## Proposal for amendments to

### ECE/TRANS/WP.29/2020/81

The text reproduced below was prepared by the experts from the 'task force on testing' lead by JRC/EC. The proposal is aimed at modifying the text of document ECE/TRANS/WP.29/2020/81 (Regulation 157 on ALKS). All modifications to ECE/TRANS/WP.29/2020/81 are given in **blue** text. Deletions are indicated by **red strikethrough** text.

## I. Proposal – Annex 5

#### 1. Cut in

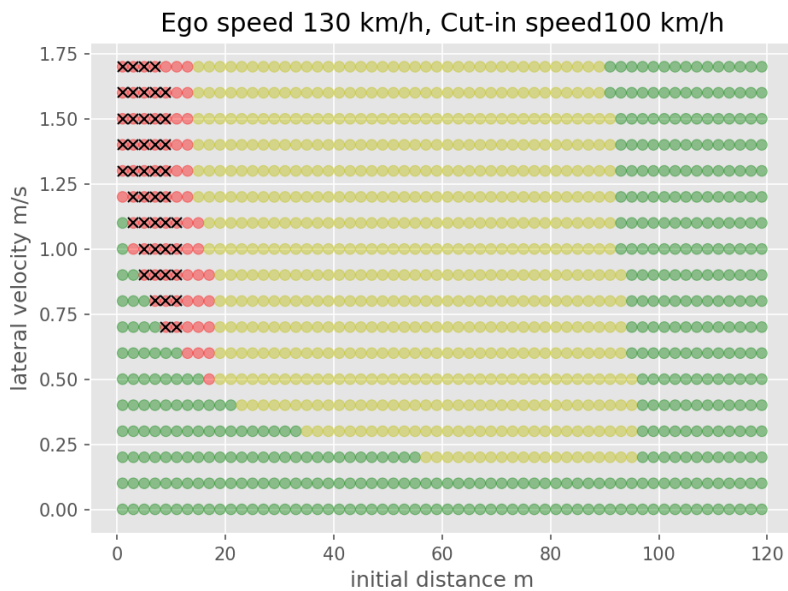
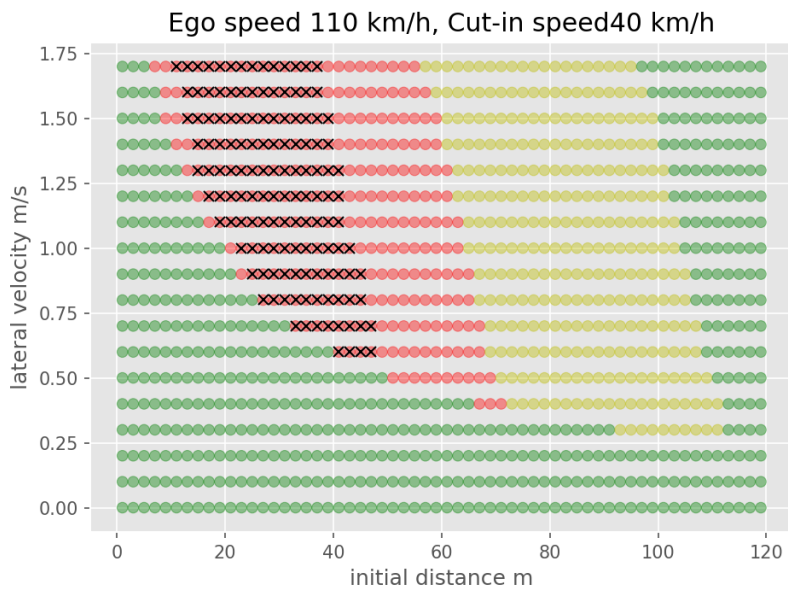
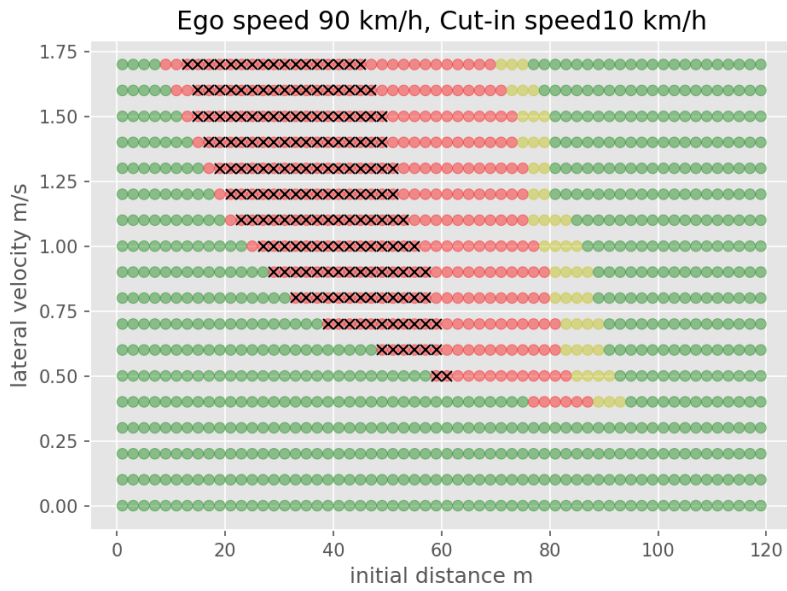
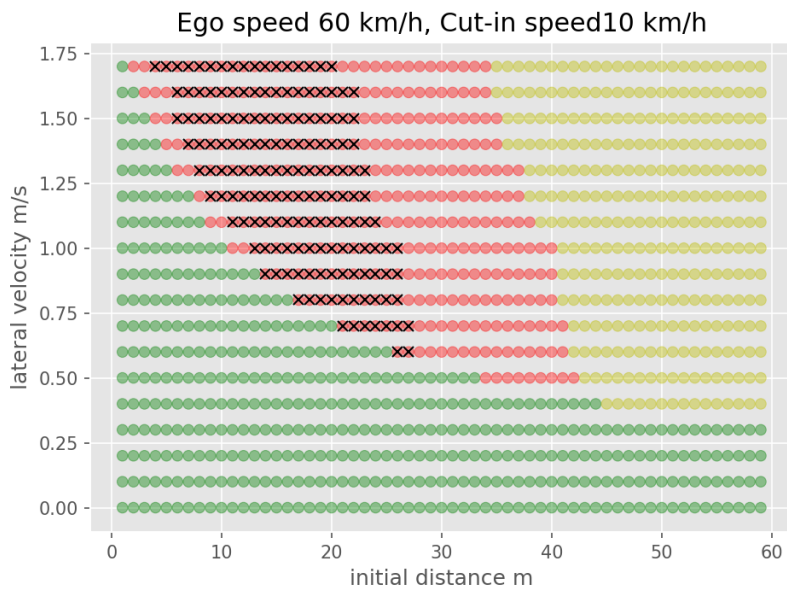
Classification of difficulty of the scenarios based on the initial parameters is done the following way in accordance to the performance model laid down in paragraph 3 of Annex 4 Appendix 3:

- Easy:  $PFS \leq 0.85$ ;
- Medium:  $PFS > 0.85$  and  $CFS < 0.9$ ;
- Difficult:  $CFS \Rightarrow 0.9$ .

Based on these equations the classification may be done for any parameter set; to show some examples, a number of figures are presented below with different ego vehicle speeds.

Alternatively the authority may also find the appropriate way to use the performance model laid down in paragraph 2 of Annex 4 Appendix 3 for the classification of the scenario difficulty.

2. Cut out

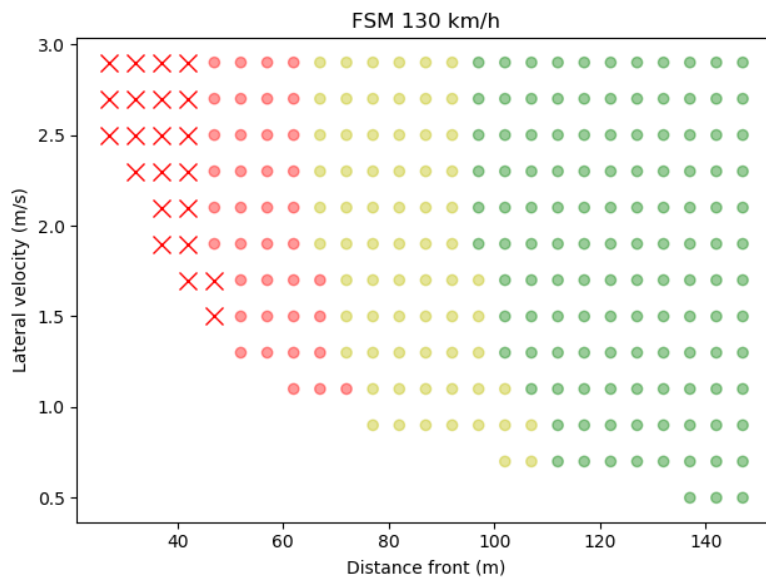
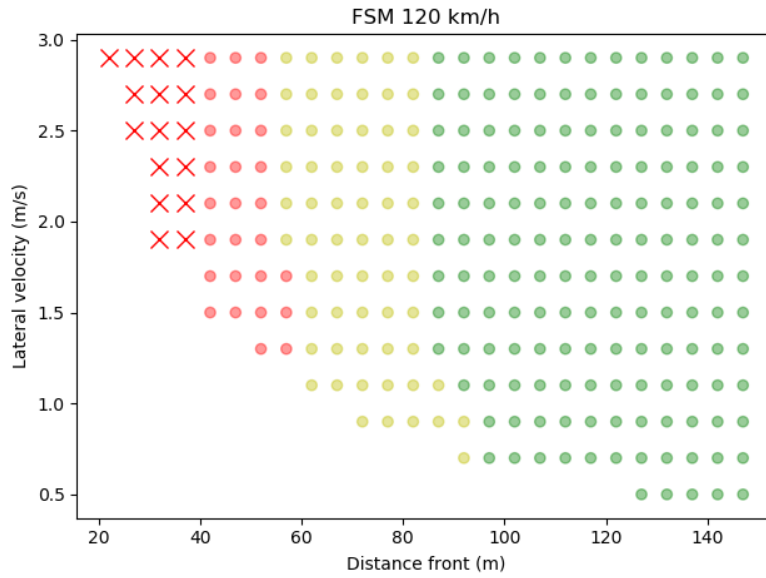
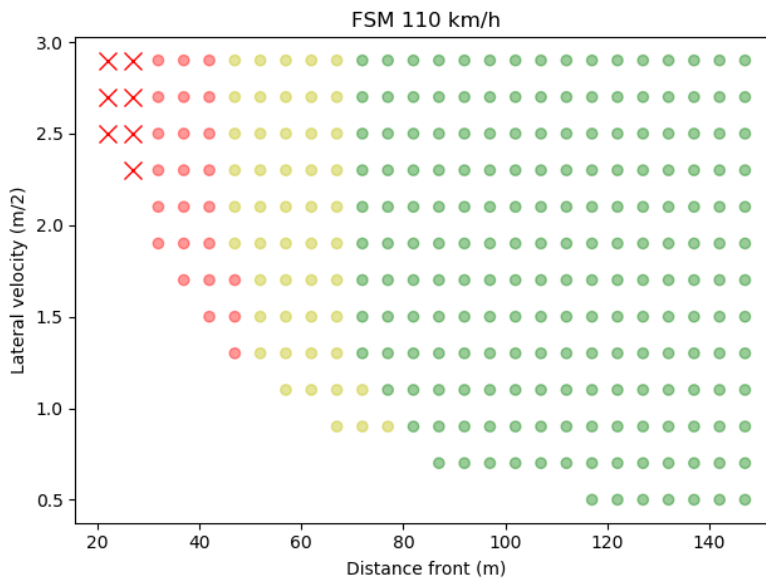
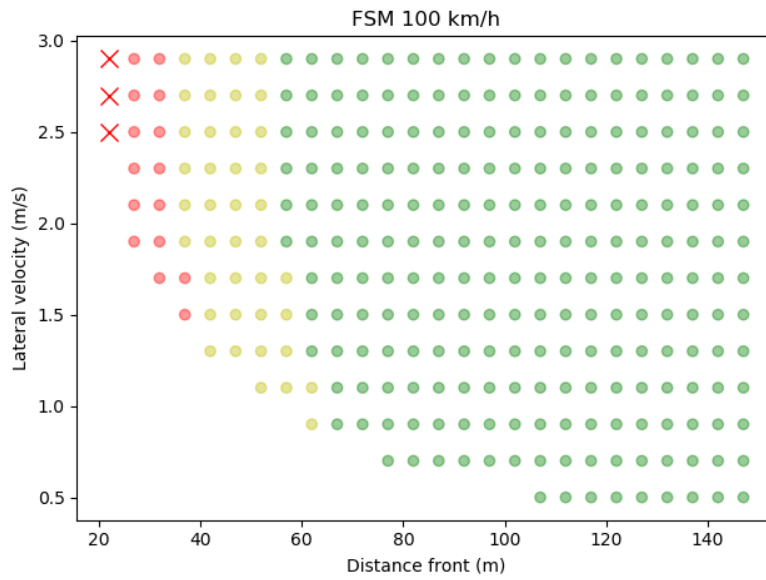
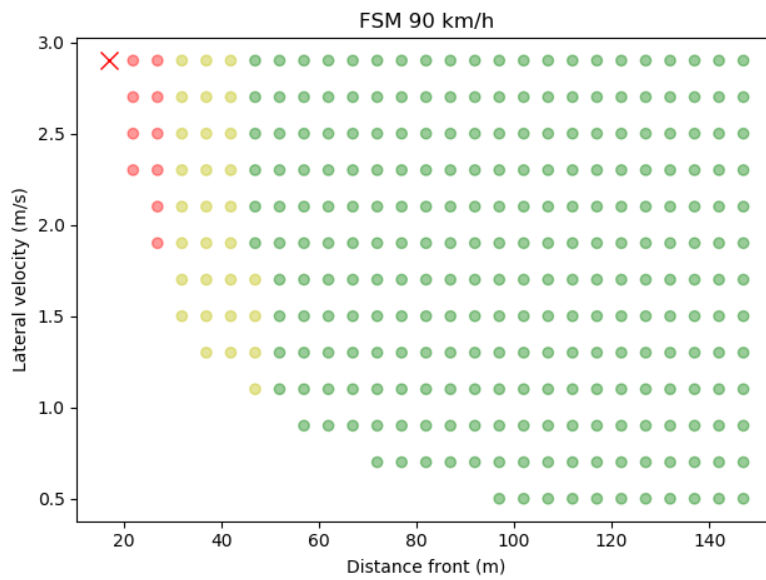
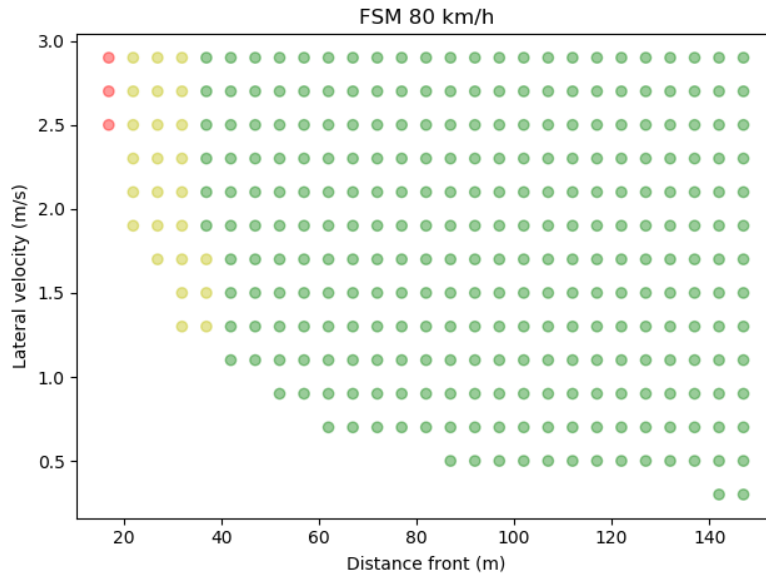
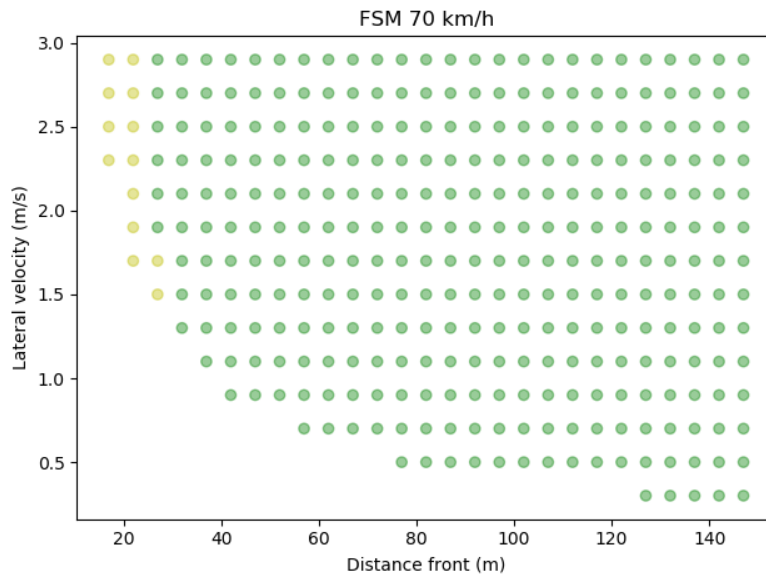
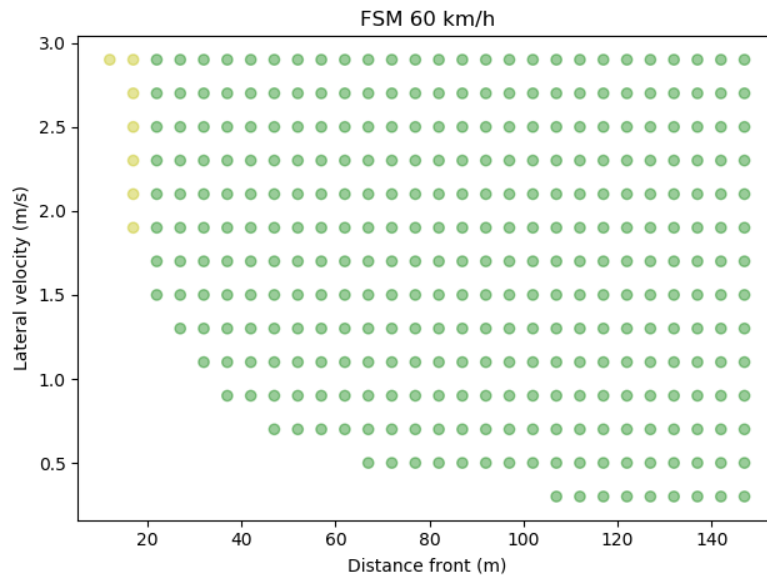
Classification of difficulty of the scenarios based on the initial parameters is done the following way in accordance to the performance model laid down in paragraph 3 of Annex 4 Appendix 3Classification of difficulty of the scenarios based on the initial parameters is done the following way:

- Easy: PFS = 0;
- Medium: PFS > 0 and CFS < 0.5;
- Difficult: CFS => 0.5.

Based on these equations the classification may be done for any parameter set; to show some examples, a number of figures are presented below with different ego vehicle speeds.

Alternatively the authority may also find the appropriate way to use the performance model laid down in paragraph 2 of Annex 4 Appendix 3 for the classification of the scenario difficulty.

Figure 13  
Deceleration

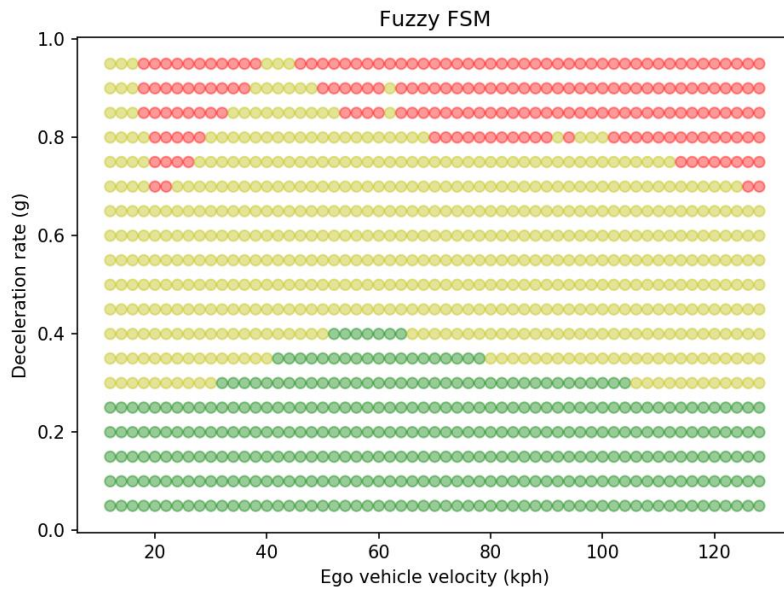
Classification of difficulty of the scenarios based on the initial parameters is done the following way in accordance to the performance model laid down in paragraph 3 of Annex 4 Appendix 3Classification of difficulty of the scenarios based on the initial parameters is done the following way:

- Easy: PFS = 0;
- Medium: PFS > 0 and CFS < 0.5;
- Difficult: CFS => 0.5.

Based on these equations the classification may be done for any parameter set. The classification matrix for the different cases is presented below in Fig. 13.

Alternatively the authority may also find the appropriate way to use the performance model laid down in paragraph 2 of Annex 4 Appendix 3 for the classification of the scenario difficulty.
